Los Alamos Environmental Restoration Records Processing Facility

**SUBJECT: DRAFT MODIFICATION FOR MATERIAL DISPOSAL AREA (MDA) L
PILOT STUDY PLAN AT OPERABLE UNIT (OU) 1148**

PROPOSED ACTION PLAN
DRILLING NEAR AREA L
TA-54, OU 1148

Pilot Extraction Study Plan

Location map of planned boreholes and pilot tests

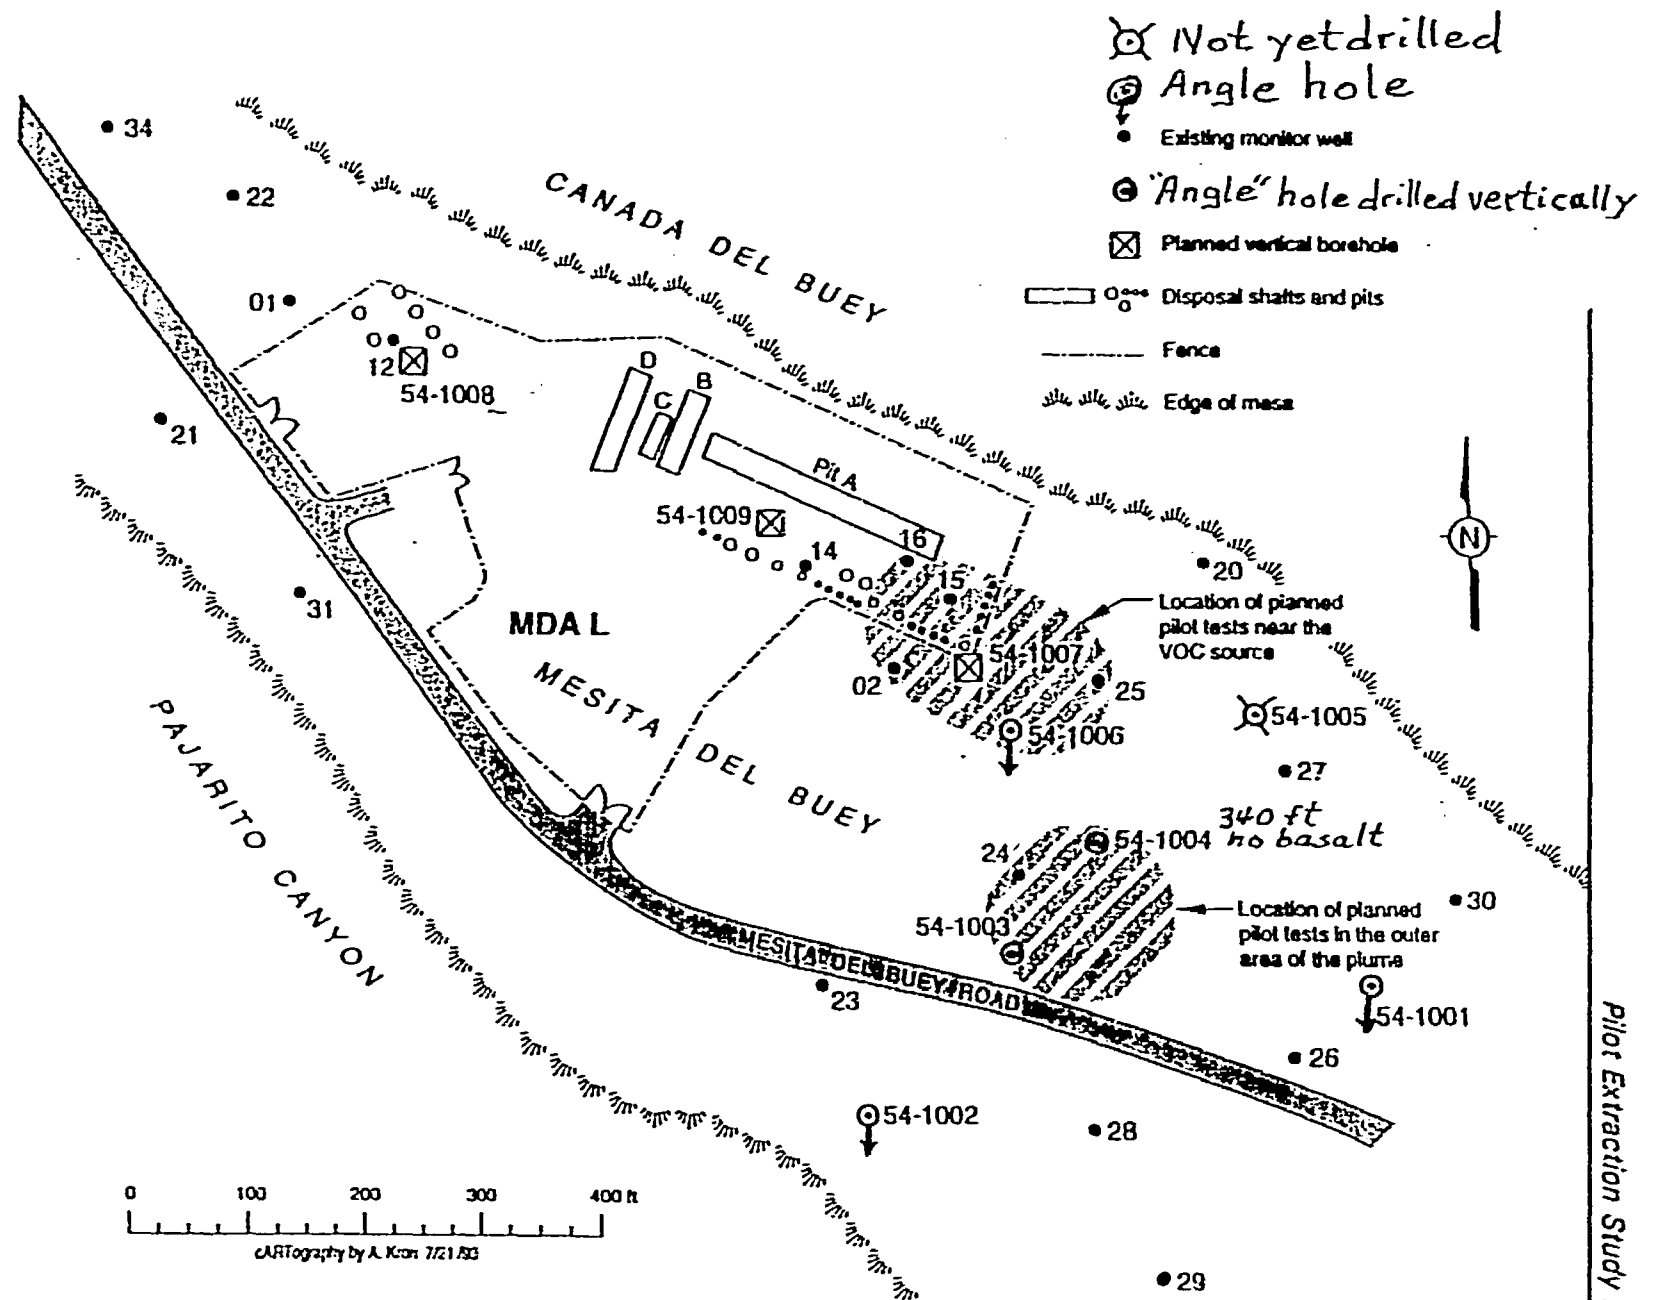
Five of the six angle holes have been drilled by hollow stem auger (see the attached map). As indicated by arrows on the map, holes 54-1001, -1002, and -1006 were drilled at angles between 20 and 25 degrees from vertical, toward the South. In each hole, the tuff extends to about 160 feet. Below the tuff is a unit of weak ash and pumice that we believe will not support a fracture. In an attempt to obtain better samples in the weak material, it was decided to drive the sampling tube ahead of the auger with a downhole hammer. This scheme did not work properly at a non-vertical angle; consequently, holes 54-1003 and -1004 were drilled vertically. The first four holes reached basalt at about 290 feet of vertical depth below the top of casing. However, the fifth hole of the sequence (54-1004) was terminated at the 340-foot depth limit of the auger rig without reaching basalt. Basaltic cobbles were noted near 300 feet, with ash below that level. The lower ash appears to be of different origin than the material lying between 160 and 300 feet. Borehole video reveals that unconsolidated powder fills hole 54-1003 at 250 feet, although it was drilled to 299 feet. Borehole video found that powder fills the other four holes at depths of ten to forty feet above the drilled bottom.

Except for the fact that the basalt is deeper or nonexistent at hole 54-1004, all five holes reveal the same stratigraphy. Because little new information would be gained from one additional hole at its location, the drilling of 54-1005 was postponed. We propose below that it be drilled in the future at a location closer to 54-1004 or at another location determined from the data of the first five holes.

Angle holes. Because there is no immediate need for more stratigraphic data, we propose to postpone drilling of the sixth angle hole. The laboratory analysis of the VOC content in cores from the previous five angle holes may reveal the need for placing 54-1005 in a different location. Meanwhile, we will evaluate the possibility of extending hole 54-1004 (by air rotary) until the basalt is located. If the top of the basalt is anomalously deep at 54-1004, hole 54-1005 might be located so as to explore further the ash-basalt contact. (Although the air rotary extension of hole 54-1004 might cause a cavity in the soft material, 54-1004 is located some 200 feet from the nearest disposal unit. A cavity at 54-1004 would have a smaller impact on contaminant migration than a cavity closer to a disposal unit.)

Deep vertical holes. We propose that these holes not be drilled as planned because of the potential for creating cavities in the weak material below the disposal units. We propose to drill three vertical holes by auger to a depth of 150 feet (within consolidated tuff) at these locations, obtaining continuous core with sampling of core at the intervals specified in the pilot study plan. Gas samples would not be collected during drilling. Because the soil is very dry, we expect that only volatile contaminants have migrated to depths greater than 150 feet; therefore, the proposed action would reveal the vertical extent of non-volatile contamination, just as well as the original deep drilling. The holes would be backfilled with cuttings (per LANL SOP) and then grouted and abandoned.
